9.3 Process Auxiliaries

The information in this section of the reference ABWR DCD, including all subsections, tables, and figures, is incorporated by reference with the following departures and supplements.

STD DEP Admin

Figure 9.3-10 Breathing Air System Flow Diagram

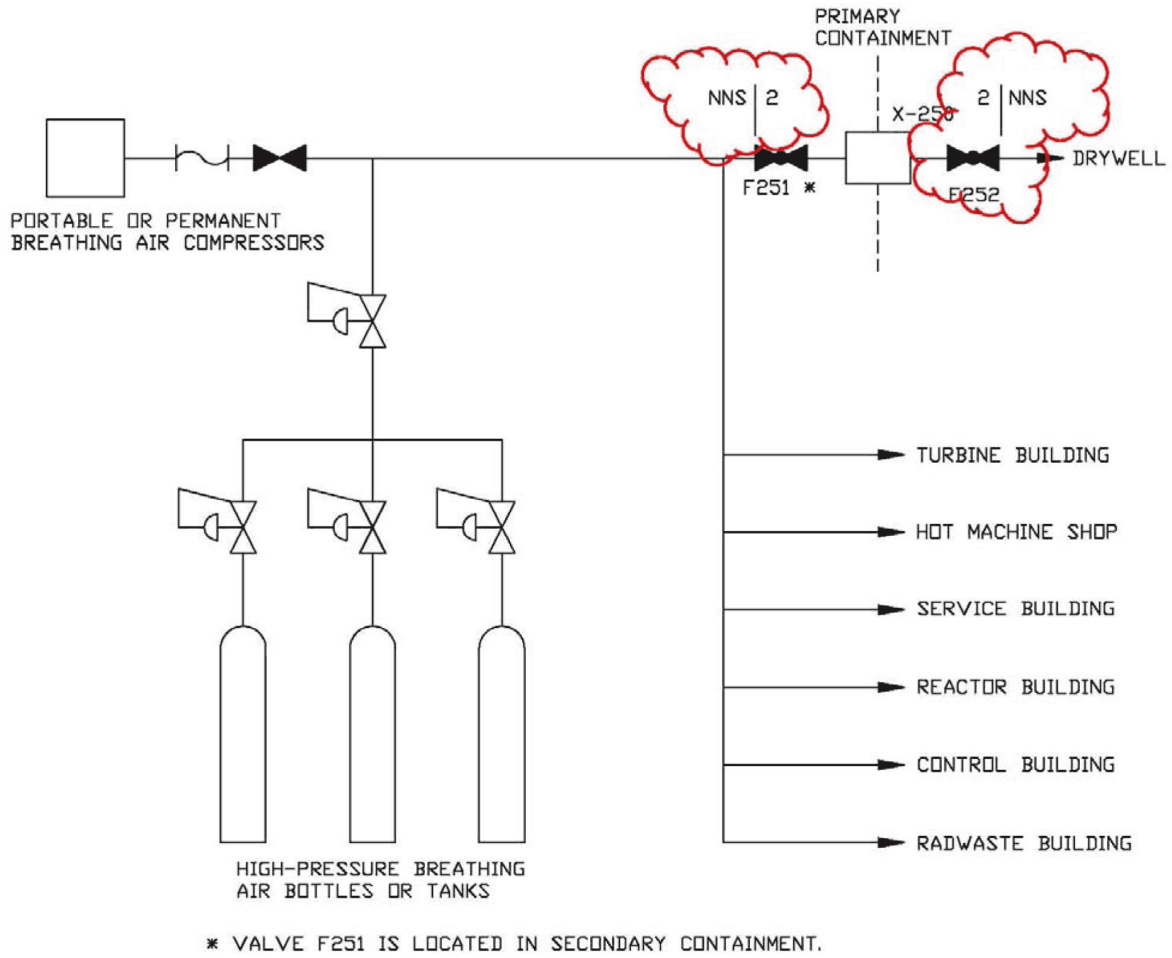
STD DEP 9.3-2

The SAS provides compressed air for tank sparging, filter/demineralizer backwashing, air-operated tools and other services requiring air of lower quality than that provided by the IAS. ~~Breathing air requirements are provided by the SAS.~~ The Breathing Air System (BAS) is discussed in Subsection 9.3.7.6.

The BAS is designed to provide compressed air of suitable breathing quality for nonsafety-related functions.

The BAS provides a continuous supply of low pressure breathing air for protection against airborne contamination while performing maintenance inspection and cleaning work. The BAS also provides a means for charging high pressure self-contained breathing apparatus.

The BAS is sized to provide 100% of the peak air consumption using the bottled breathing air supply and a portable permanent breathing air compressor supply system, as needed. The compressor(s) will be of the oil-less, breathing air type.

The BAS flow diagram is shown in Figure 9.3-10.

<u>Pressure (design of BAS)</u>	<u>689 kPaG</u>
<u>Pressure (design of self-contained breathing apparatus charging)</u>	<u>17.23 MPaG</u>
<u>ANSI Compressed Gas Association (CGA) 7.1-1997, "Commodity Specification for Air"</u>	<u>Air Quality Grade D</u>

Figure 9.3-12 Non-Radioactive Drainage System

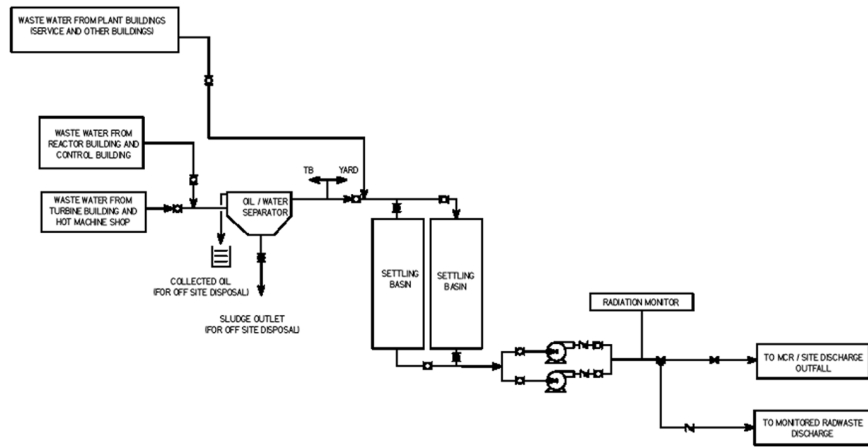
The design of the continuation of the non-radioactive drain system from the ABWR Standard Plant Buildings to the site discharge outfall is provided in Figure 9.3-12 and is discussed in this subsection.

The conceptual design information in this subsection of the reference ABWR DCD is replaced with the following site-specific supplement.

The non-radioactive drain system collects waste water from plant buildings (Reactor, Turbine, Control, Service, and other buildings). A system composed of collection piping, curbs, and pumps is provided. Non-radioactive waste water from the Turbine Building, Reactor Building, hot machine shop and the Control Building is routed to a dedicated oil/water separator where oil and settled solids are removed for off-site disposal. The non-oily, non-radioactive effluent is sent to dual settling basins. Non-radioactive waste water from the Service Building and other buildings is sent directly to the dual settling basins. Means are provided to perform any required tests or analyses required by the discharge permit. The non-radioactive liquid effluent is

discharged to the Main Cooling Reservoir through permitted outfall(s). If radioactivity levels exceed the limits for discharge, the flow from the non-radioactive drains has the capability to be diverted to the radioactive effluent portion of the radwaste system. Normally, if low levels of radioactivity are detected, it is quantified and discharged via the normal outfall. Higher levels of radioactivity may require a permitted "batch" discharge via the radwaste effluent radiation monitor. The non-radioactive drainage system is illustrated in Figure 9.3-12.
